PJM Manual 15:

Cost Development Guidelines

Revision: [4718](#)

Effective Date: [June 1, 2011](#)

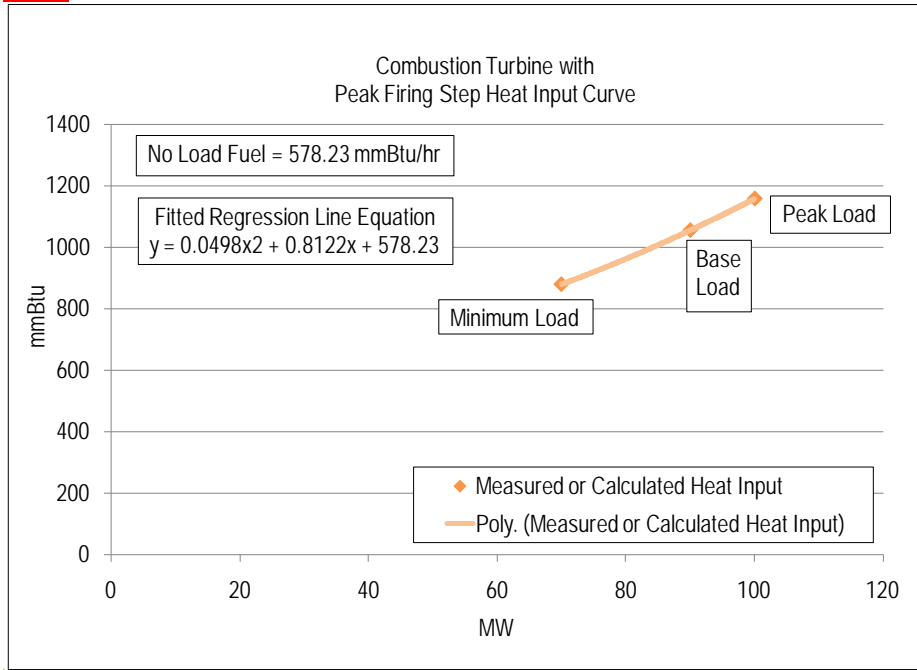
An example of collecting heat input values as a function of output and performing a regression analysis on the data to obtain the no-load fuel for a typical fossil steam unit is shown below:

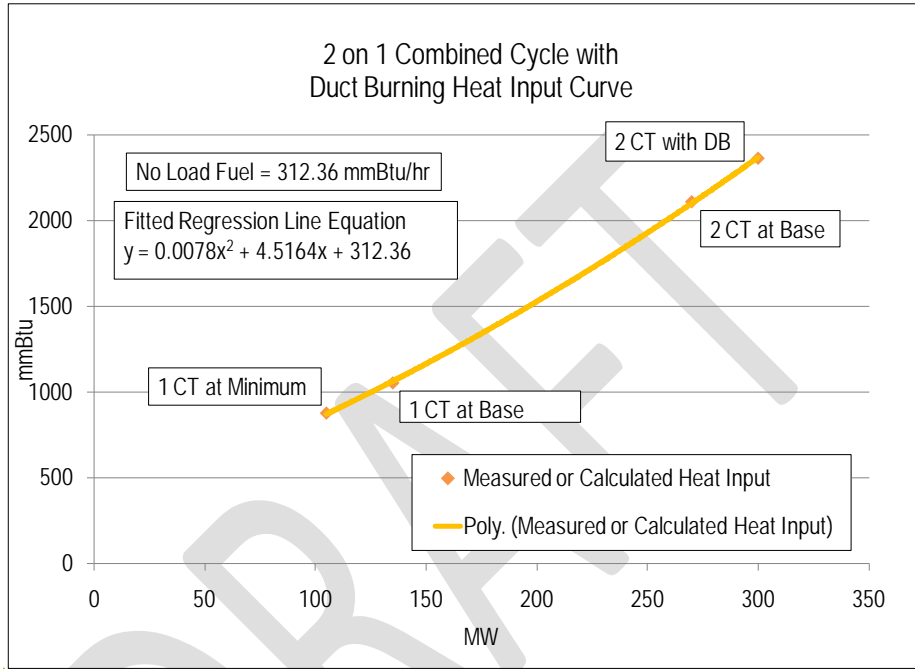
An example of using the design heat input curve and performing a regression analysis to obtain the no-load fuel for a simple cycle combustion turbine with peak firing is shown below:

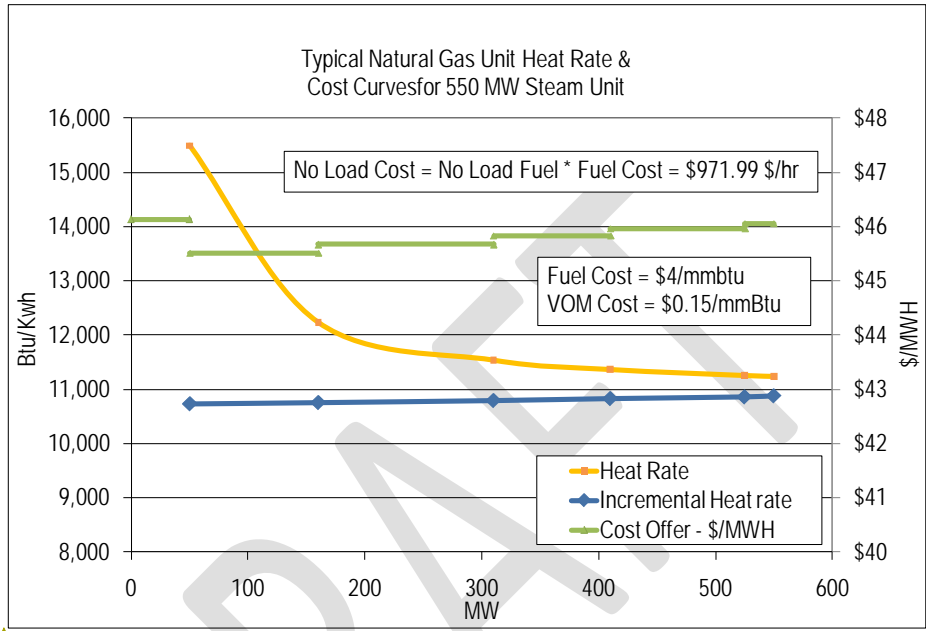
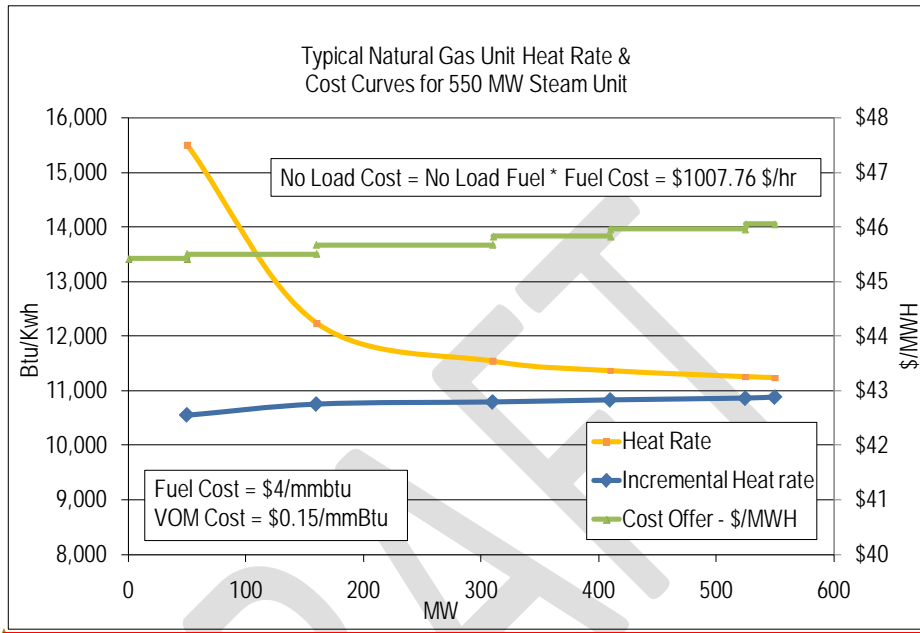
An example of adjusting the no-load cost after calculation follows. Heat input values as a function of output was collected for a typical fossil steam and a regression analysis was performed to obtain the no-load.

Once the No-Load Cost was calculated, the unit's cost curve was then developed. However due to the quality of the heat input data, the first increment of the cost offer was greater than the second increment.

The No-Load cost was then raised until the first increment of the cost offer was less than or equal to the second increment, producing a monotonically increasing curve.
